SUNDRY NOTICES AND REPORTS ON WELLS
Do not use this form for proposals to drill or to re-enter an abandoned well. Use form 3160-3 (APD) for such proposals.

8. Well Name and No.
DEXTER FEDERAL 7

Dexter Federal #7 Wellbore diagram

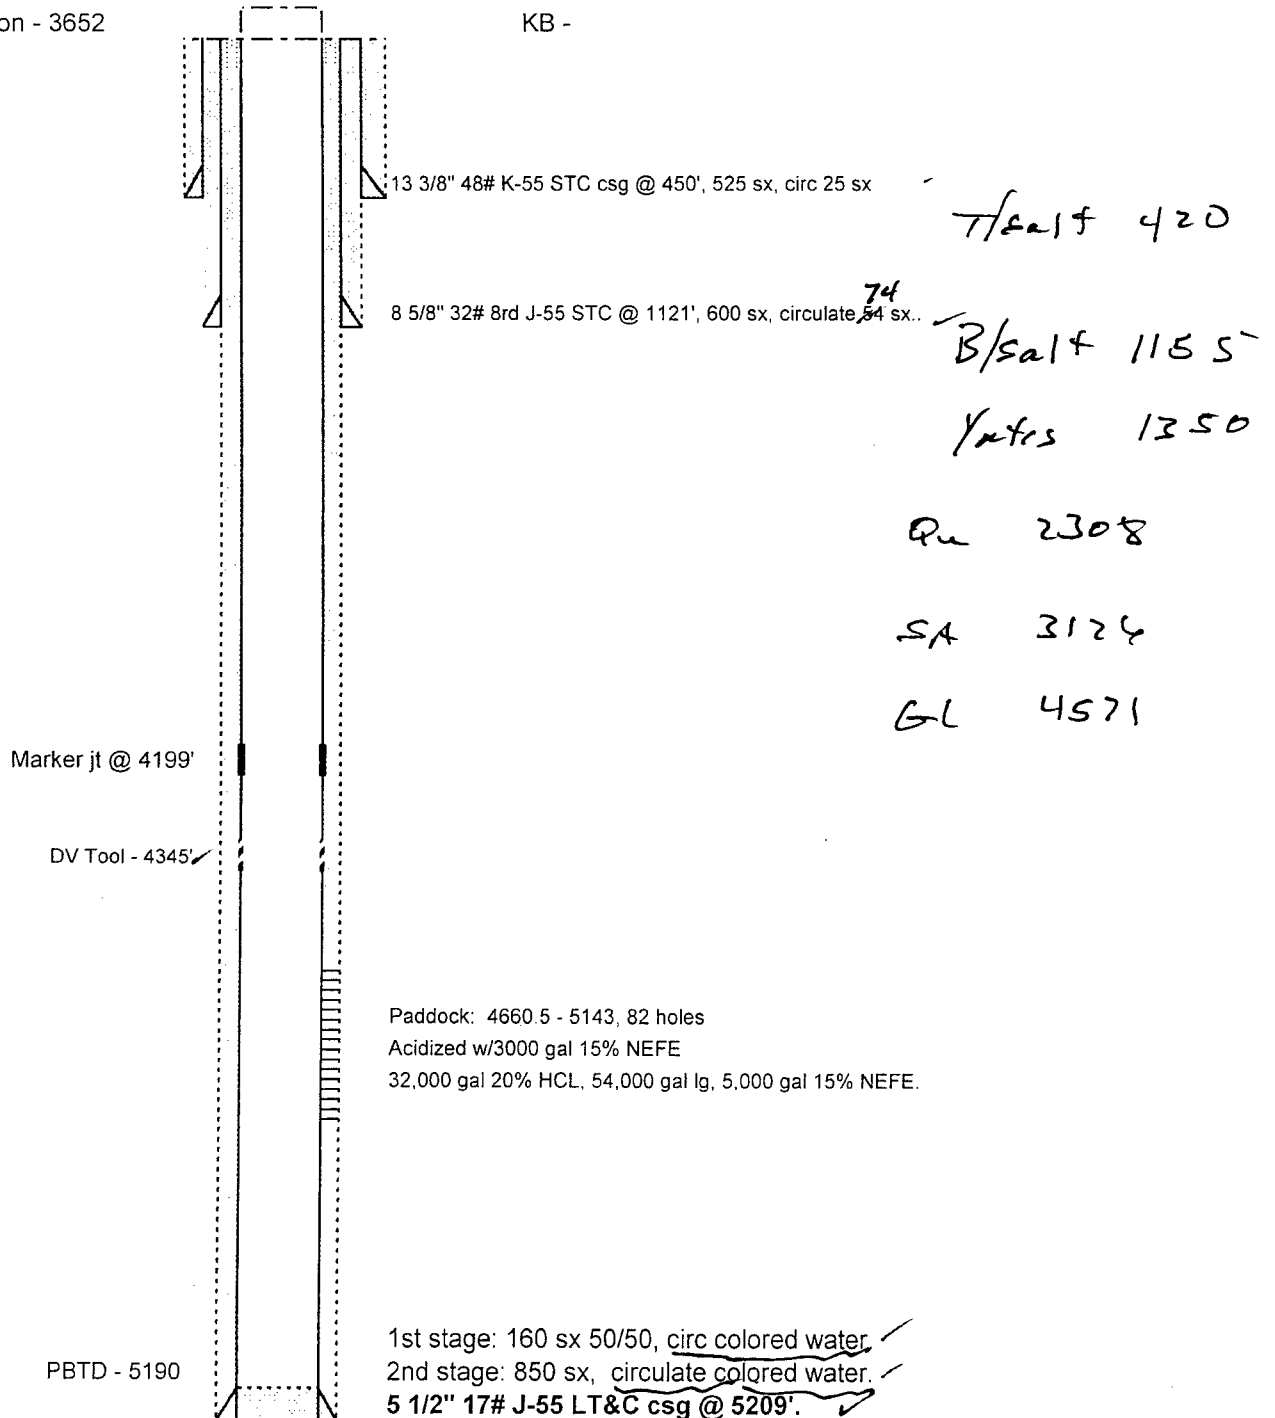
1. Set CIBP @ 4630. Circulate hole w/ mud laden fluid. Pressure test csg. Spot 25 sx @ 4630-4530'.
2. Spot 25 sx cmt @ 4395-4295'. WOC & Tag. (DV Tool). 140' min plus.
3. Spot 25 sx cmt @ 3100-3000'. (San Andres) 3176-3046
4. Spot 25 sx cmt @ 2750-2650'. (Greyburg) 120' min.
5. Spot 25 sx cmt @ 1465-1365'. WOC & Tag. (Yates)
6. Spot 25 sx cmt @ 1170-1070'. WOC & Tag. (BTM of Salt & Shoe)
7. Spot 25 sx cmt @ 500-400'. WOC & Tag. (Top of Salt & Shoe)
8. Perf & Sqz 45 sx cmt @ 100-Surface.
9. Cut off well head, weld on Dry Hole Marker.

Below ground level dry hole marker required
